Technical Analysis of the "Trim Line"

April 1, 2009

John Koreny, HDR, Inc.
Charles Brockway Sr., Brockway Engineering, Inc.
Willem Schreuder, Principia Mathematica
Jon Bowling, Idaho Power
David Blew, Idaho Power

Location of Buhl-Thousand Springs Reach "Trim Line"

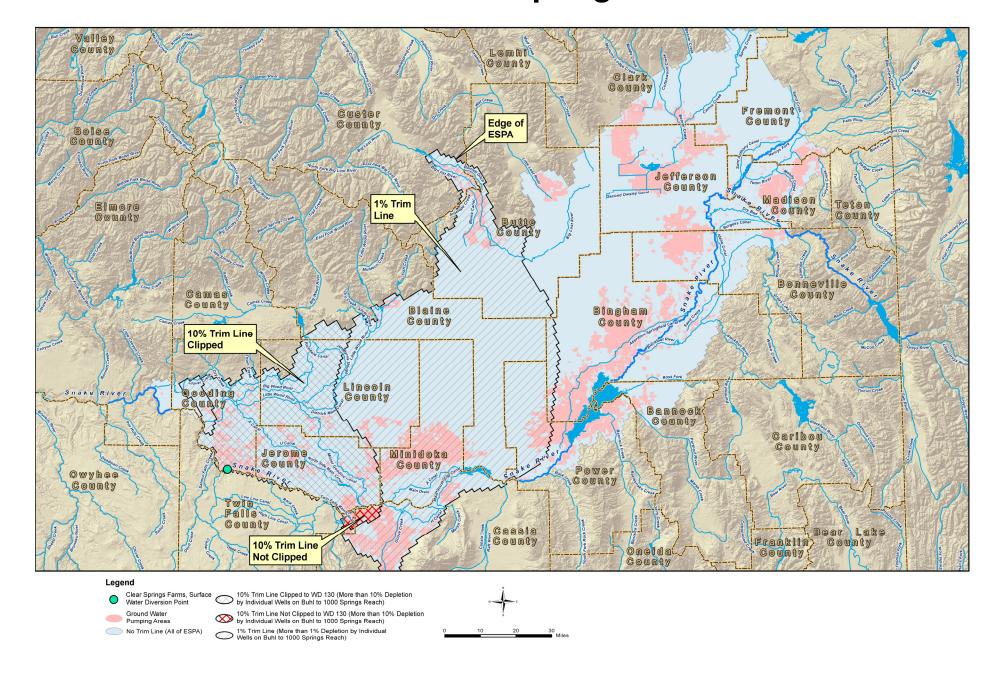
10% trim line identifies about only ½ of the impacts on the spring reach

Location of Devils Washbowl-Buhl Reach "Trim Line"

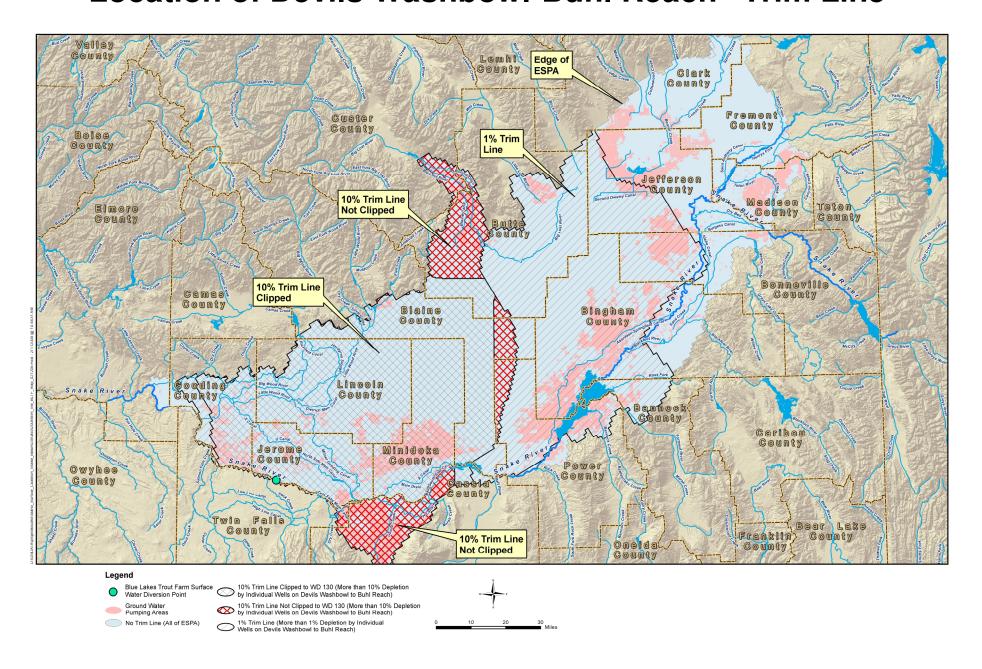
10% trim line identifies about only ½ of the impacts on the spring reach
